**Reference: McNeely Landing Subdivision
Part of Lot 14 & 15, Concession 10 (Beckwith), Town of Carleton Place
Draft Plan of Subdivision First Submission – Agency & Public Comment
Responses
County File No.: 09-T-21003
Our File No.: 119221**

This letter has been prepared in response to public and agency review comments received between August 30, 2021 and March 29, 2022, regarding the initial submission filed with the County of Lanark in June 2021 and application deemed complete on July 16, 2021. All comments received are listed below with responses provided in ***bold italicized*** text.

Figure 1: “Mother Tree” Location

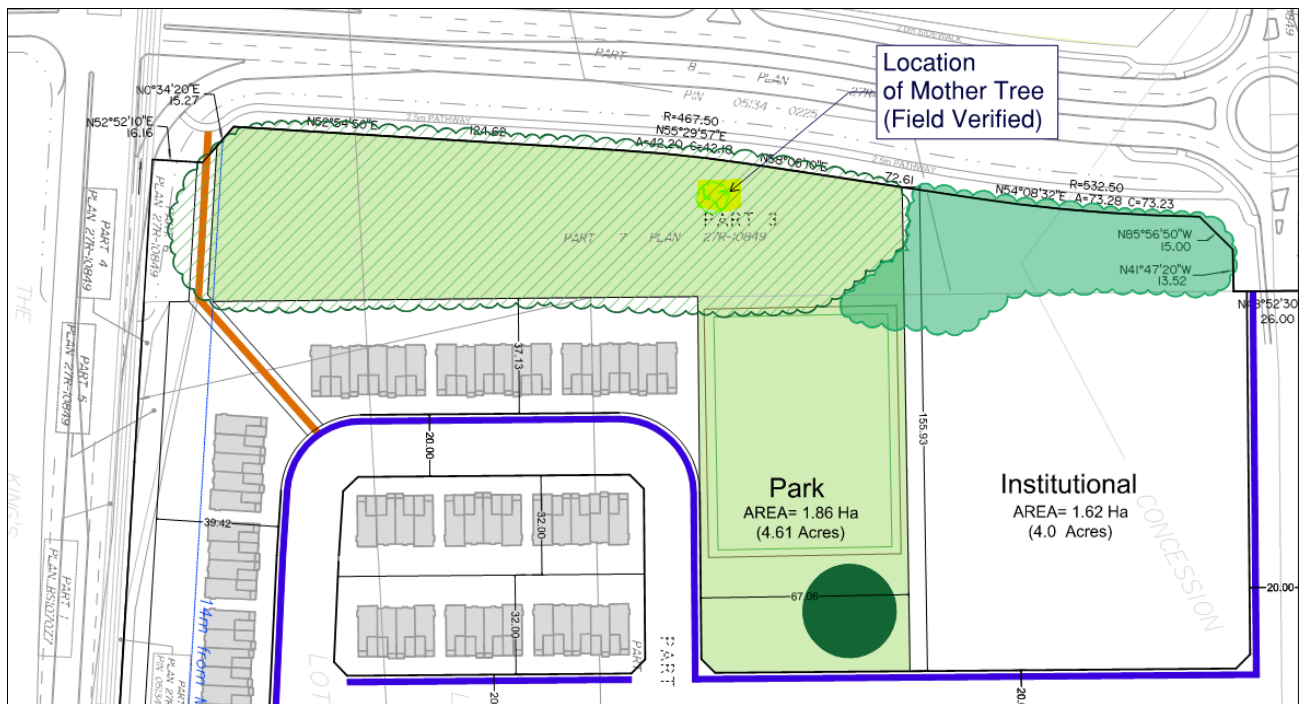
- The Deciduous Forest in the Northwest corner has a number of larger trees not indicated in the report; the large Maple “Mother Tree” as identified by the Town, being one of them. This tree and other larger maples need to be protected and preserved. It is recommended that a 10 meters buffer of this forest be protected along Highway 15 for the benefit and screening to the Community.

The proposed Park Block (Block 217) includes the woodland area in the northwest corner of the subject lands. The intent is to preserve the existing woodland within the proposed parkland block. The “Mother Tree” has been surveyed and is located within the proposed parkland block, as noted in the Figure below.
